**Report for:** Record of Decision Taken Under Delegated Authority

**Title:** Hornsey Park Community Streets – Hornsey Park Road/Clarendon Road Pedestrian safety works.

Hornsey Park Community Streets – Statutory Consultation  
**Pedestrian Safety and Accessibility in Hornsey Park**  
**Road between Clarendon Road and Avenue Road**

**Hornsey Park CS Statutory Consultation 10 January – 1 February 2017**  
**Hornsey Park Road - between Clarendon Road and Avenue Road**

HORNSEY PARK ROAD  
 CLARENDON ROAD GATEWAY

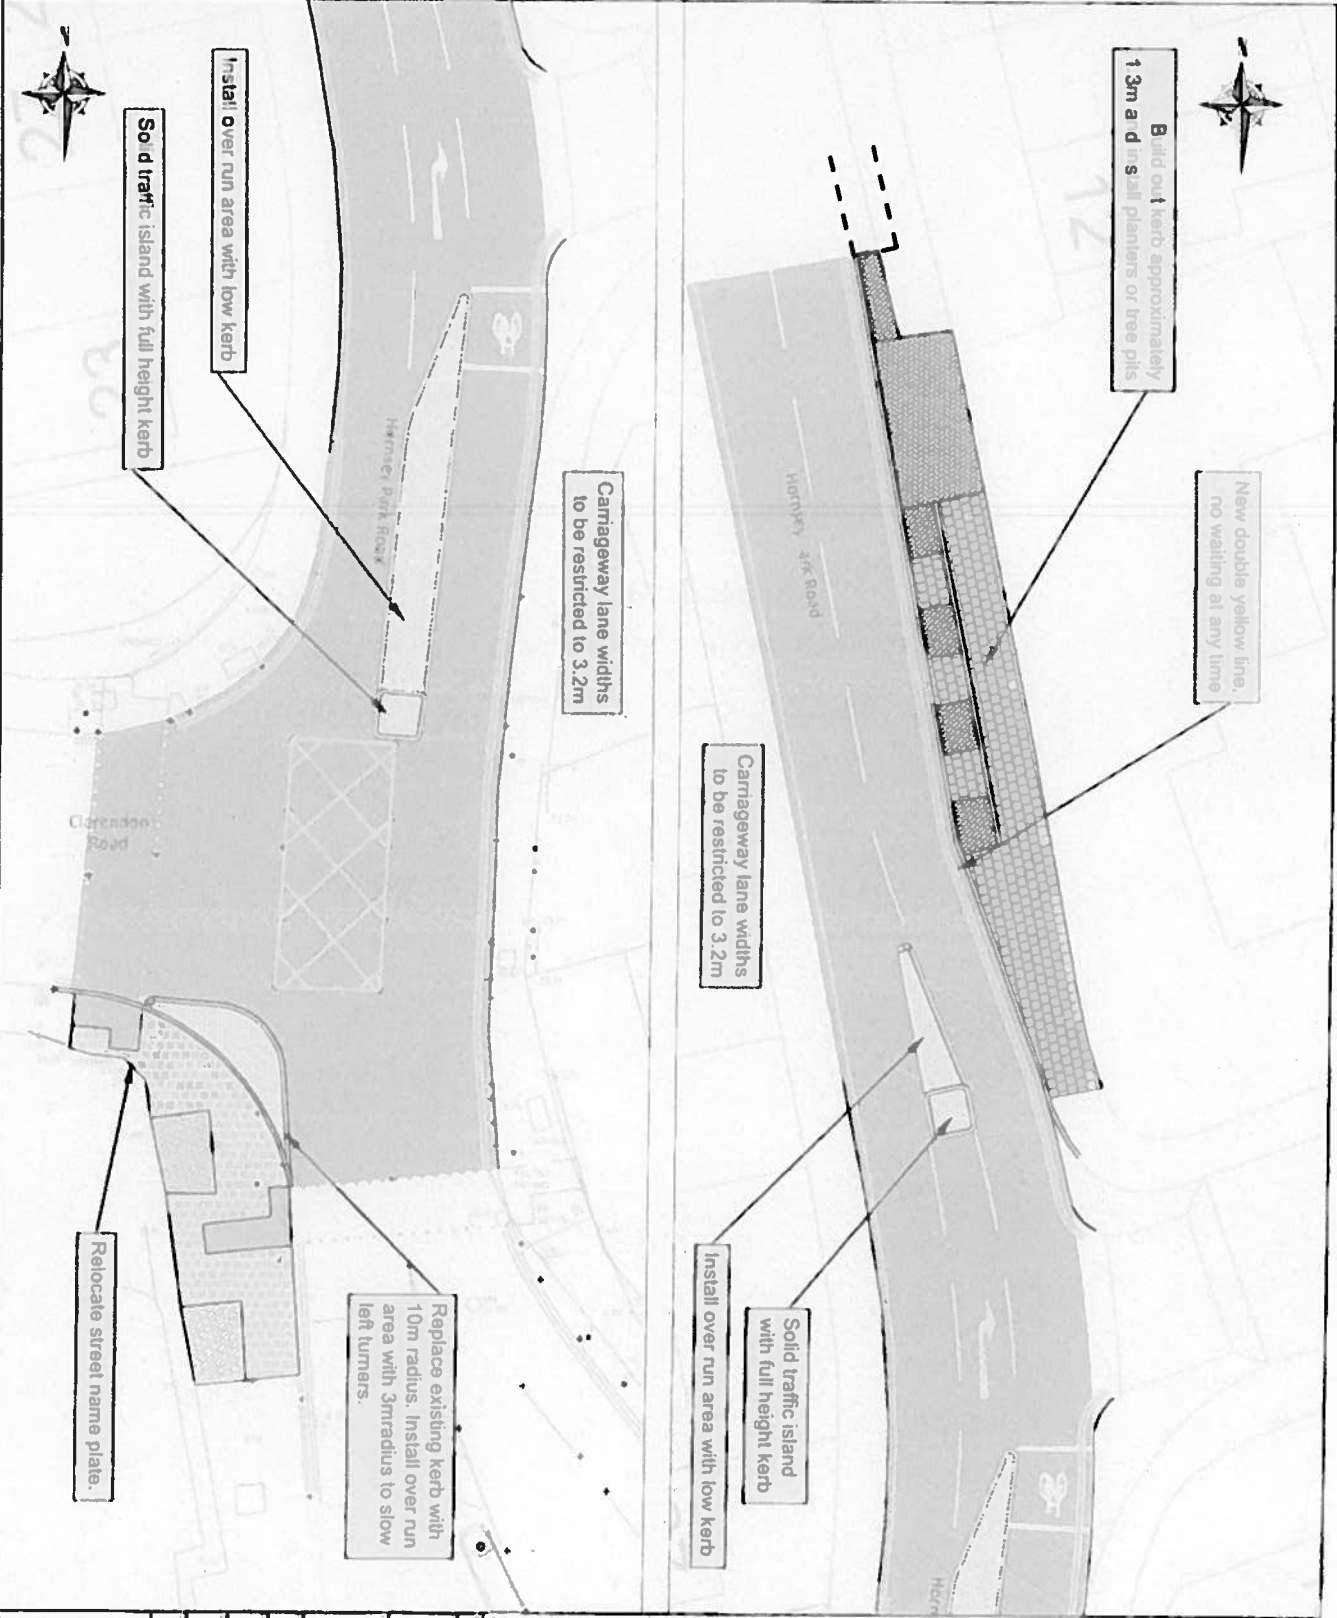
Overall Support / Object	Comment	Response
Other	<i>Remove traffic lights which cause more trouble - drivers stop at the wrong places - tailbacks also run into main road. Leave trees already in place.</i>	Removal of the signal junction is well beyond the scope of this project. Haringey would not support the removal as the signals currently assist the safe movement of traffic and pedestrians through the junction. there are no proposals to remove existing trees.
Other	<i>Why not use money to repair gaps &amp; potholes - speed bumps on Alexandra road and the Avenue are not in good condition - parts cannot be seen in the dark.</i>	We will pass on concerns regarding the condition of Alexandra Road to our Highways Maintenance Team.
Other	<i>We are broadly in acceptance of your proposals providing the yellow box is expanded and enforced for vehicles blocking the junction when trying to exit Clarendon road because they cannot get across before the lights change. Cars come across from HPR and block the exit too. Not good.</i>	Due to a recent change in regulations, we are now permitted to extend this yellow box marking across the junction as requested. We will include this as part of our final proposal.

Object	<p><i>This would be an expensive and unnecessary scheme which would add to existing parking congestion and would be of no benefit whatsoever.</i></p>	<p>As part of the Community Streets initiative, this scheme has been developed in conjunction with local residents groups. The design looks to reduce speeds in the vicinity to improve safety and improve the public realm. Whilst there is no clear impact on parking bays in the area we do proposed to replace an unused single yellow line on the east side of Hornsey Park Road with No waiting at any time restrictions.</p>
--------	---	---

*"We would be very concerned if any lane width is reduced to 3.2m, such a width is likely to encourage close overtaking and consequently increase risk for people cycling here: 3.2m is not narrow enough to discourage drivers from attempting to overtake. The design implies that people should cycle directly in front of traffic, which only a minority of people are prepared to do and doing so is likely to be unpopular with drivers who will perceive they are being deliberately obstructed. The London Cycle Design Standards (at paragraph 4.4.2) has specific guidance on lane widths. Even if the lane width is reduced to 3m or more to further discourage overtaking, the combination of this and the high volume of through traffic on this residential road would make cycling here very uncomfortable, particularly as the proximity to the traffic lights on Turnpike Lane mean close tailgating by drivers is a certainty. As you will know HCC have long represented the concerns of our members on the danger created by the traffic islands on Wightman Road - close passes and dangerous tailgating by drivers is a regular occurrence on this road due to the traffic islands deliberately bringing cycles and drivers into conflict. Consequently we are most surprised and disappointed that similar interventions are being suggested here.*

*Another concern is the overrun build-out proposed at Clarendon Rd. Although the similar arrangement at the new Bus 91 turn round seems to work well, this one looks wider and the ambiguity between road and pavement could be a problem for pedestrians and cycles.*

*Having discussed the proposals with other HCC members, we suggest the excess road width at this location be used for cycle lanes. This could be delivered at less expense than the work proposed and should be installed with physical protection to produce the desired lane narrowing effect to slow traffic. We suggest any work is complimentary to the long-overdue major redesign of the very unsatisfactory Turnpike Lane/Wightman Rd junction.*

- 6.1.1 LBH response :** We attempt to work with HCC in the development of all schemes in the borough, the section to which they refer in the LCDS states that widths between 3.2m and 4.5m should be avoided as it represents lane widths where uncertainty of space for overtaking can lead to drivers passing too close to cyclists. For this reason we were suggesting to lower the lane widths to 3.2m. Having received their suggestion we have reviewed the vehicle classification data in this location and found that the number of HGV and Public service vehicles are 7.6% therefore we are happy to further reduce this narrowing to 2.9m.

The over run feature installed at Tottenham Lane works well. As the brief for this project is to improve pedestrian safety and accessibility at this junction we would be averse to removing a feature that has been proven to slow traffic elsewhere. It is envisaged that this feature will improve safety and accessibility on a currently fast and semi obscured corner, that is the only place where pedestrians interact with live traffic within the area of works. Safety and accessibility for pedestrians is one of the key drivers of this scheme.

- 6.1.2** *Following ongoing discussion with HCC we have made further alterations to the design, to implement a southbound feeder lane to the advanced stop line at the junction. This was achievable without detracting from the traffic calming effect of the proposals.*

- 12.2 Concerns regarding the 3.2m carriageway widths have been mitigated by reducing the lanes to 2.9m. This will serve to further slow traffic and remove ambiguity regarding opportunities to overtake cyclists.

## Comments

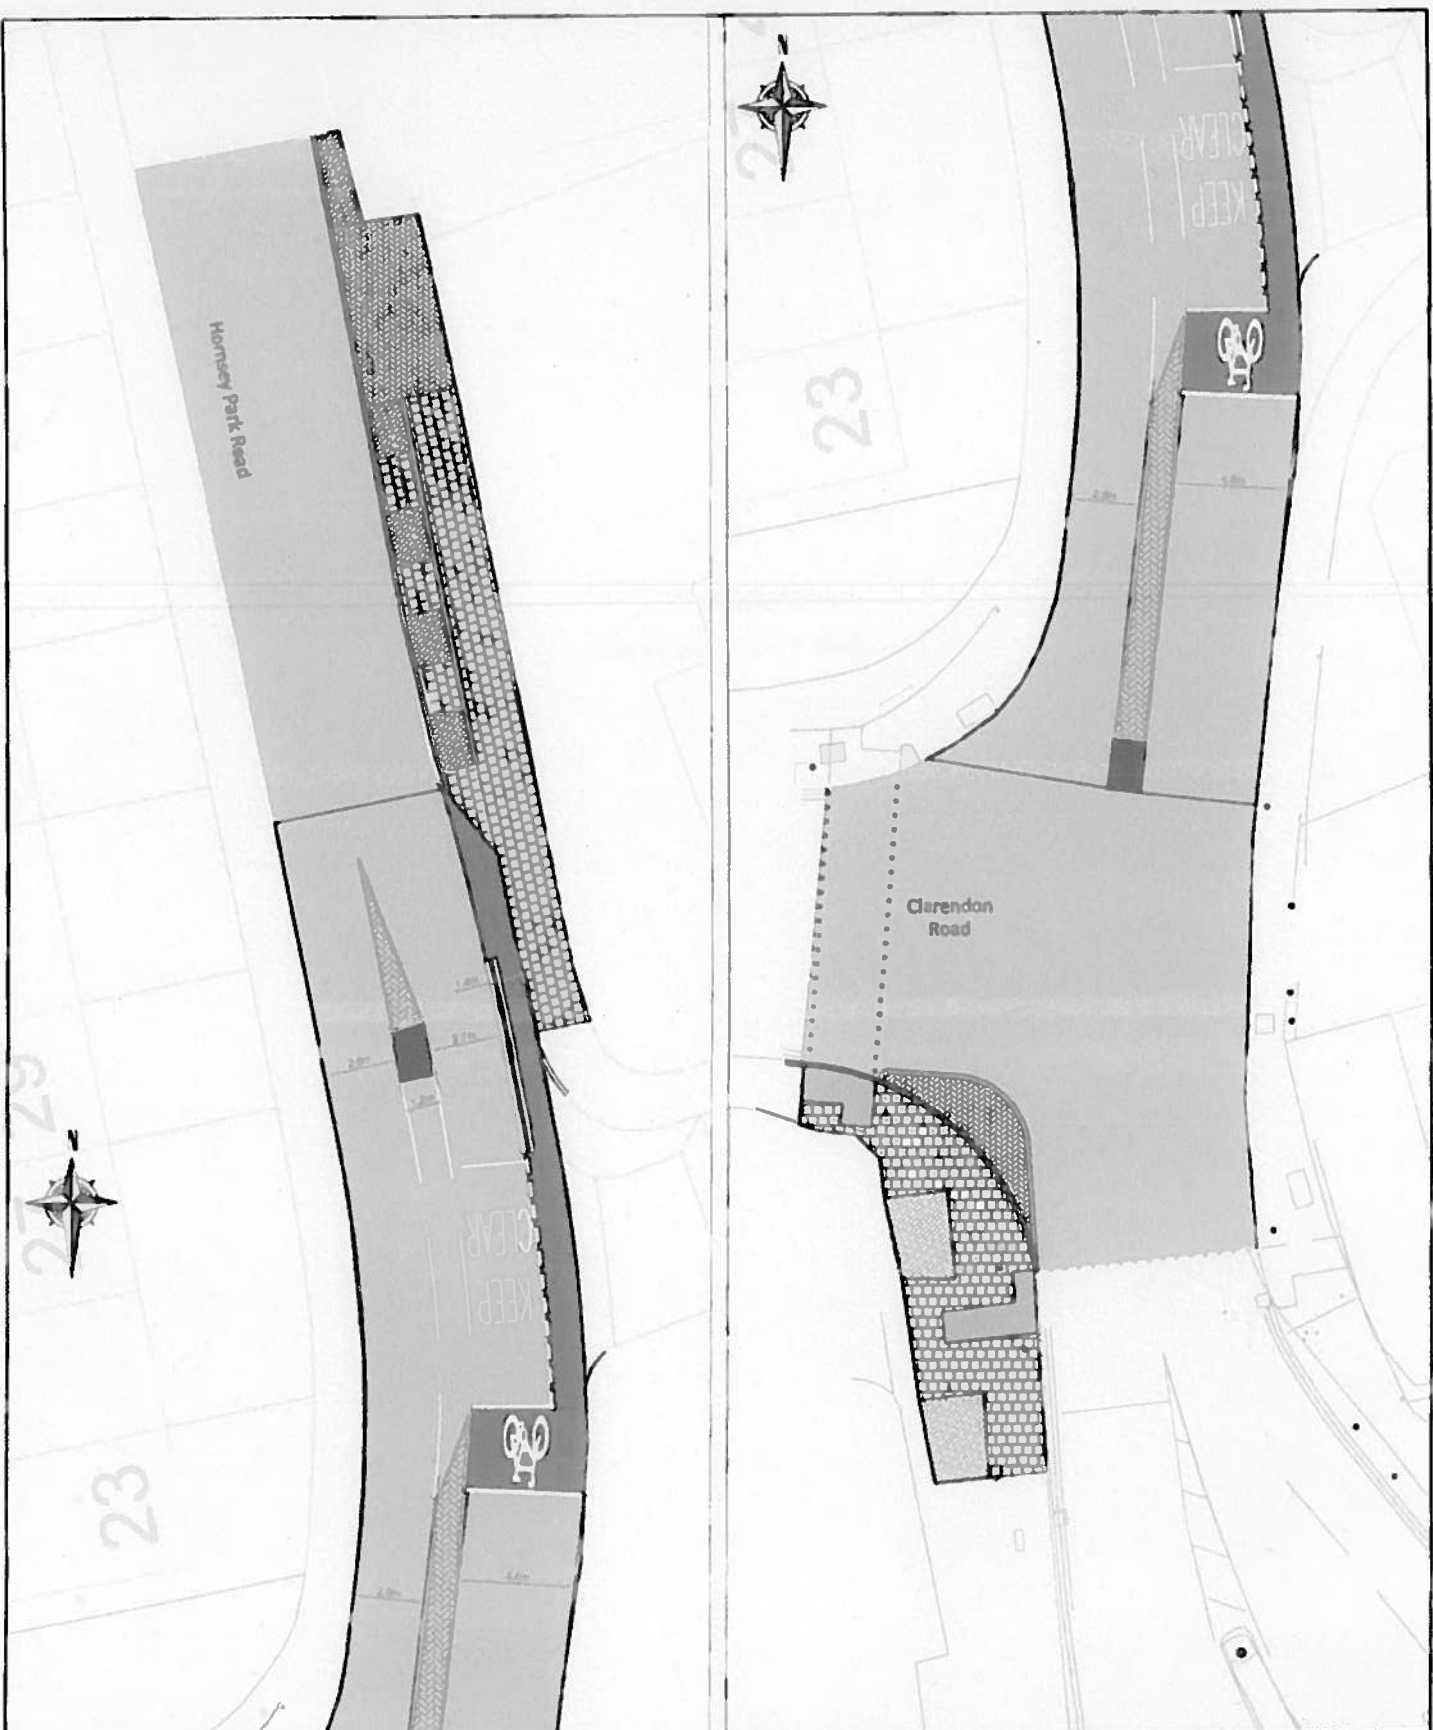
Road and no	Support or object	Comments
Hornsey Park road 28	Object	this would be an expensive and unnecessary scheme which would add to existing parking congestion and would be of no benefit whatsoever
The Avenue 24a	Other view	Remove traffic lights which cause more trouble - drivers stop at the wrong places - tailbacks also run into main road. Leave trees already in place.
The Avenue 24	Other view	Why not use money to repair gaps & potholes - speed bumps on Alexandra road and the Avenue are not in good condition - parts cannot be seen in the dark.
Clarendon Road	Support	
not stated	Support	Support measures. The footpath in HPR has not been fixed for 30 years.
Hornsey Park Road 35	Support	Also suggests traffic calming measures, eg speed bump halfway between the proposed works and the raised zebra crossing on HPR. Many drivers are speeding along the straight stretch and driving dangerously.
Hornsey Park road 31c	Support	I agree that a pedestrian area should be implemented as it is currently unsafe for children to cross. Traffic levels are very high at rush hour which prevents both children and adults from crossing safely.

Clarendon road 25/27	Other view	We are broadly in acceptance of your proposals providing the yellow box is expanded and enforced for vehicles blocking the junction when trying to exit Clarendon road because they cannot get across before the lights change. Cars come across from HPR and block the exit too. Not good.
Clarendon Rd 33	Support	Please consider extending the box junction to both sides of the road. This will help people turning right out of Clarendon Rd.

<p>Non Resident (HCC)</p>	<p>Object</p> <p>Haringey Cycling Campaign (HCC) ..... very concerned if any lane width is reduced to 3.2m, as it is likely to encourage close overtaking and increase risk for people cycling here: 3.2m is not narrow enough to discourage drivers from attempting to overtake. Even if the lane width is reduced, the combination of this and the high volume of through traffic on this residential road would make cycling here very uncomfortable, particularly as the proximity to the traffic lights on Turnpike Lane mean close tailgating by drivers is a certainty. HCC have long represented the concerns of our members on the danger created by the traffic islands on Wightman Road - close passes and dangerous tailgating by drivers is a regular occurrence as the traffic islands deliberately bring cycles and drivers into conflict. We are most disappointed that similar interventions are being suggested here. Another concern is the overrun build-out proposed at Clarendon Rd. Although the similar arrangement at the new Bus 91 turn round seems to work well, this one looks wider and the ambiguity between road and pavement could be a problem for pedestrians and cycles.... We suggest the excess road width at this location be used for cycle lanes. This could be delivered at less expense than the work proposed and should be installed with physical protection to produce the desired lane narrowing effect to slow traffic. We suggest any work is complimentary to the long-overdue major redesign of the very unsatisfactory Turnpike Lane/Wightman Rd junction. Overall this presents a disappointing outcome for this Community Streets project - Hornsey Park Rd will remain open to large volumes of non-residential through traffic and therefore unattractive to cycling and walking, as well as detrimental to the health of the resident community and adjoining communities. I understand modal filtering is not possible because the alternative route has bends which are too tight as a relief bus route, however this would not preclude the use of a bus gate on Hornsey Park Road, meaning that only cycles and buses would be permitted to use Hornsey Park Rd as a through route, while leaving the area fully accessible to residents when driving. Local residents have a long-running campaign for the parallel Mary Neuner Road to be designated the main through route in this area, therefore we think our proposal would be popular with residents. The local residents association (Parkside Malvern) have indicated that they wish to ensure that the outcomes of this project will enable residents and visitors to choose to cycle more regularly. Unfortunately HCC do not see this project delivering that outcome, and in the case of the road narrowings, may have the opposite effect.</p>

<p><b>Not stated</b></p>	<p><b>Object</b></p>	<p><b>My objection is that the plans do not meet the standards required. The 2014 London Cycle Design Standards (LCDS) advise against lane widths of 3.2m as this creates the temptation for motorists to pass people on bikes within the lane when there is insufficient space, this is exacerbated with the central islands installed as part of this plan, creating pinch-points. In contrast, if recommended lane widths of 2.5-2.9m were installed, this would not be required. It would have the additional advantage of giving greater effect to the gateway installation and help slow traffic. The narrower lane widths are also more appropriate for a 20mph road which should not be carrying significant volumes of HGV traffic.</b></p>
<p><b>Beresford Rd 115</b></p>	<p><b>Object</b></p>	<p><b>The current plans for Hornsey Park Road around Clarendon Road do not appear to be in the best interests of the road users in that area. While the motive of making the road better for vulnerable users and generally reducing the volumes and speeds of motor traffic is sensible, the current scheme has widths that are too narrow and features such as islands that will increase conflict rather than reduce it. Please do not proceed with this scheme as it stands and instead choose an approach that doesn't lead to vulnerable users being squeezed by motor vehicles.</b></p>
